# **MY3 FINAL MONITORING REPORT**

## **BRAHMA SITE**

**Response to DMS Comments – MY3 (2023)**

Brahma Mitigation Site (DMS #100092), Contract No. 7743  
Cape Fear River Basin 03030002, Alamance County  
USACE Action ID No. SAW-2019-00126, DWR Project No. 20190158

**CURRENT CONDITIONS PLAN VIEW**

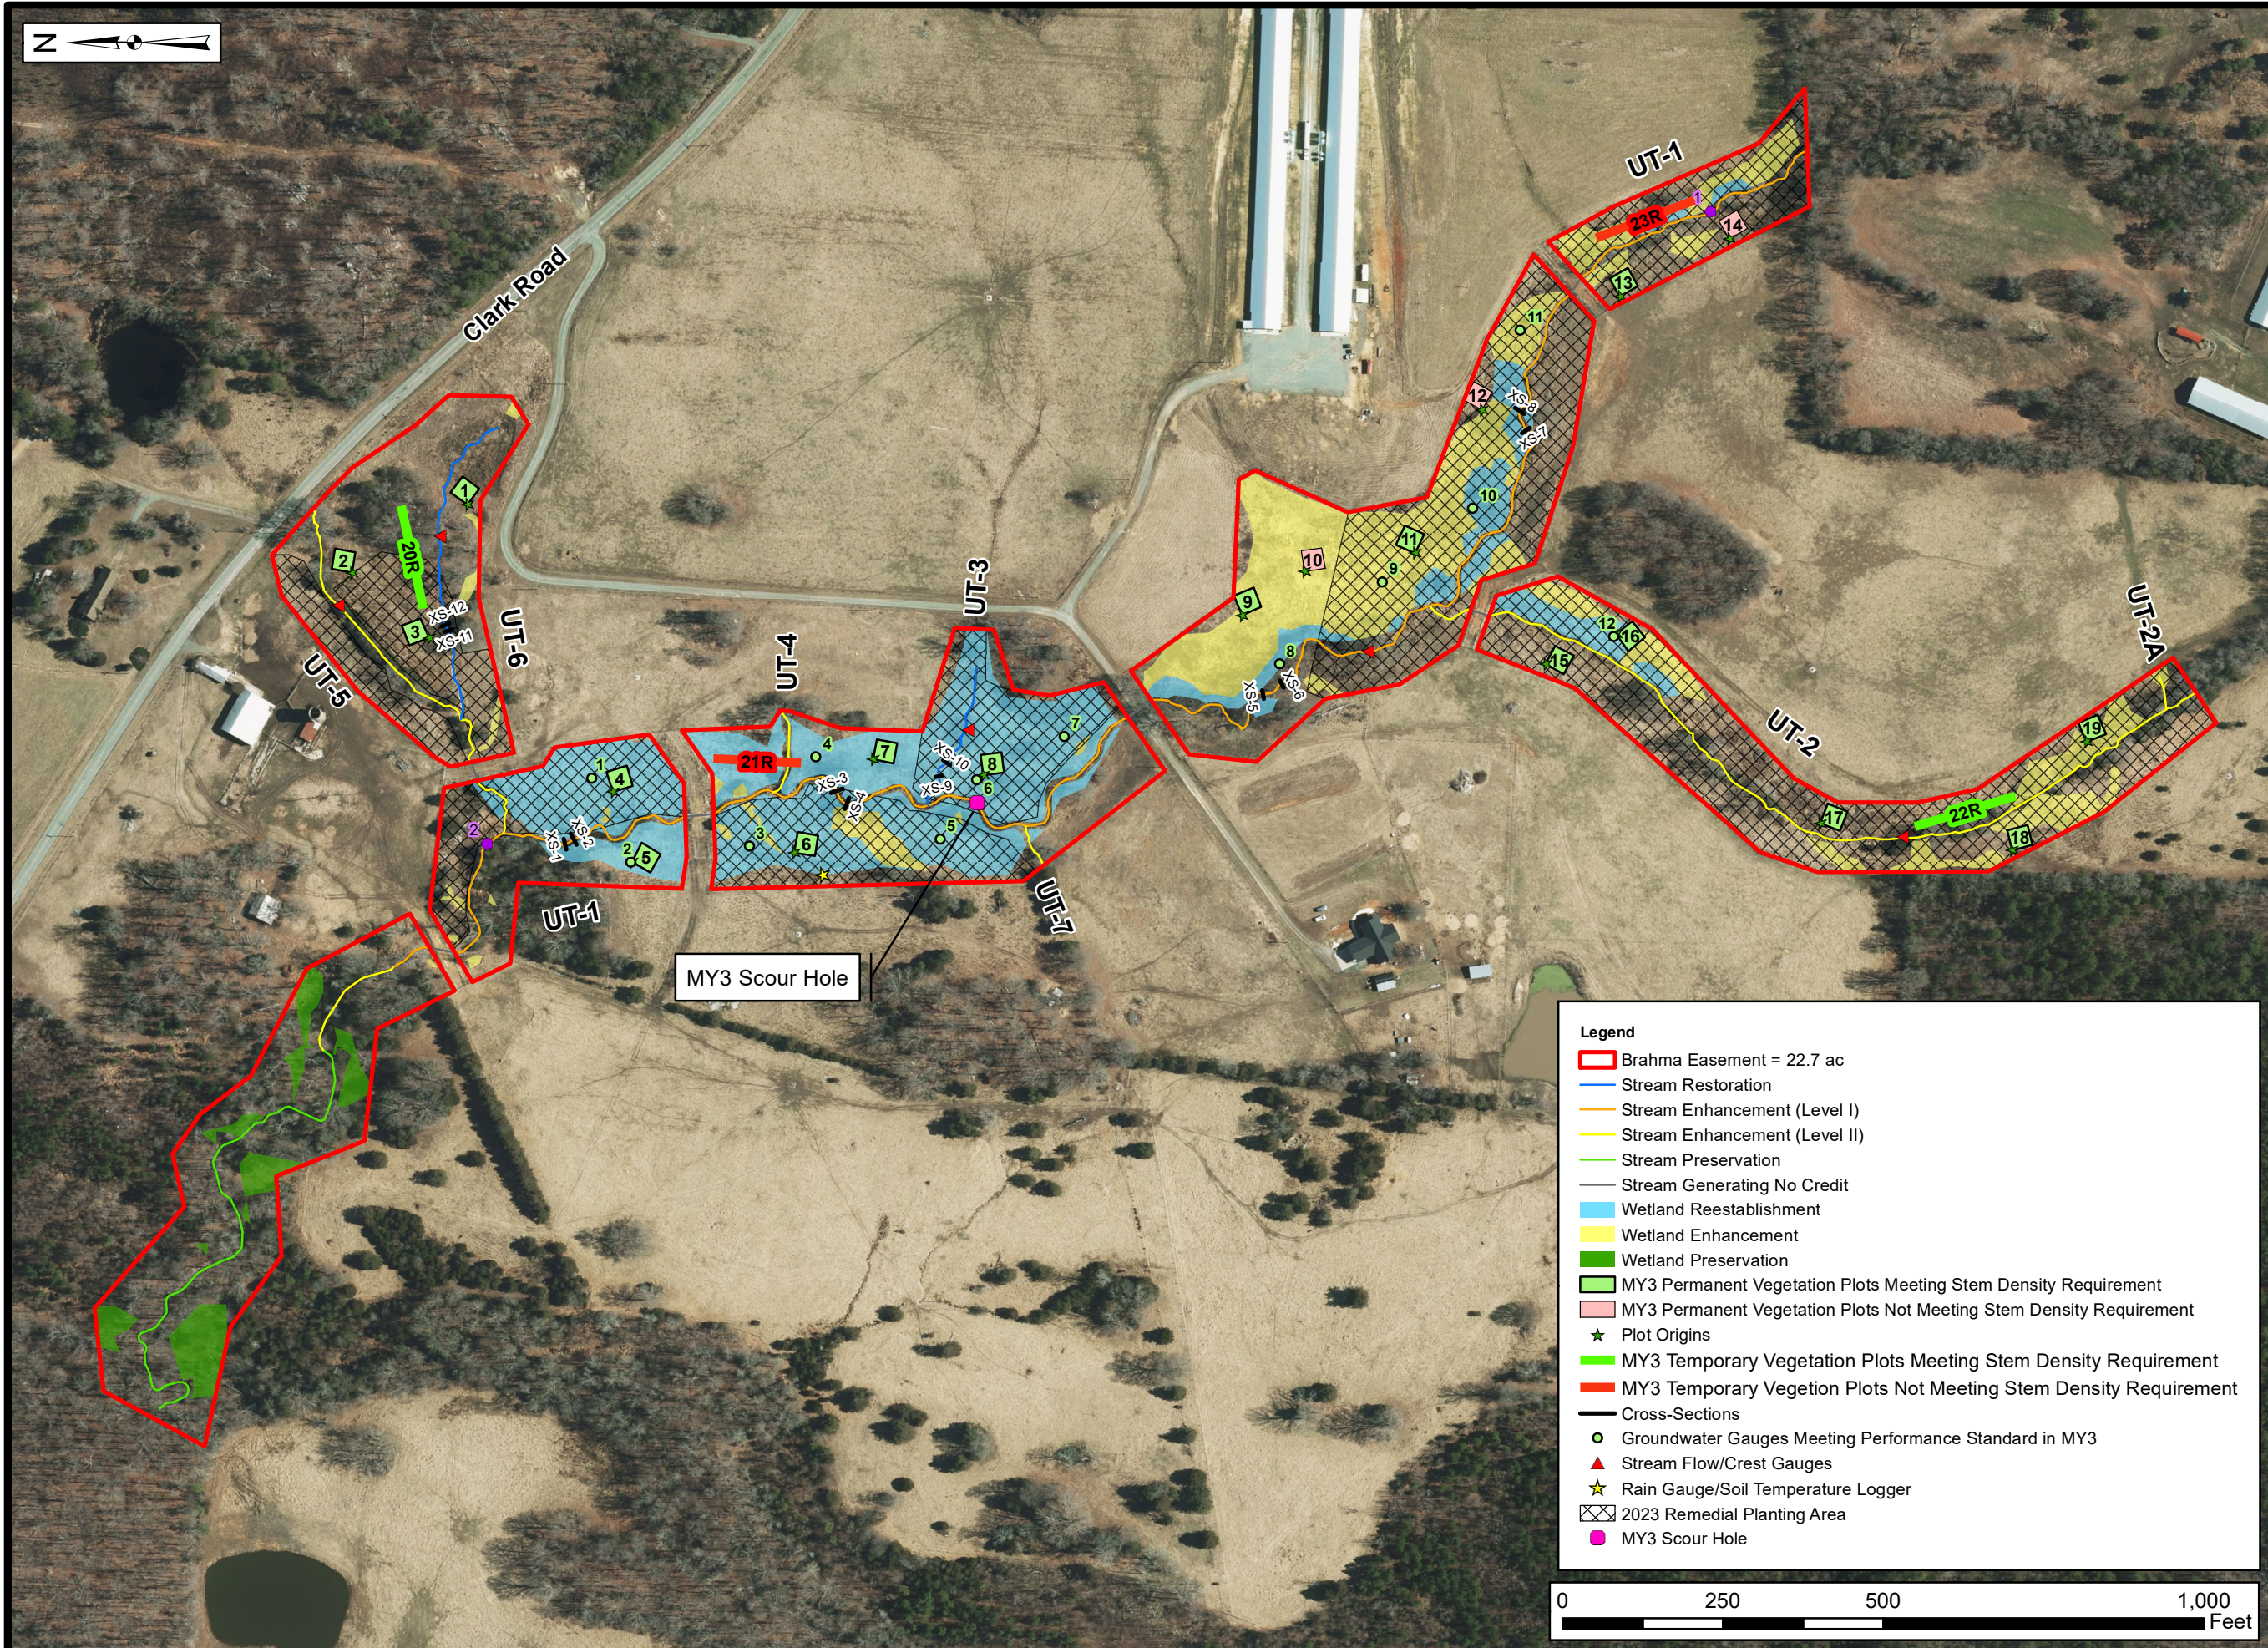
1. During site visit, minor scour was observed on UT-1 a short distance upstream of UT-3 on outside of meander bend. Recommend watching the area to ensure that this does not become an issue. Overall, this site looks great.

Response: The observed scour location is approximately four (4) feet in length and is on the right bank of UT1 within an Enhancement 1 portion of the stream. At this location exiting trees along the top of bank were avoided during construction. The scour is downstream of an existing root-wad and the channel is vertically stable. RS was able to plant five (5) live stakes in the scour area on 01/24/2024. Species included silky dogwood and black willow. RS will continue to observe this area during the monitoring period. The scour location has been added to the CCPV, and the shapefile is in the digital submittal.
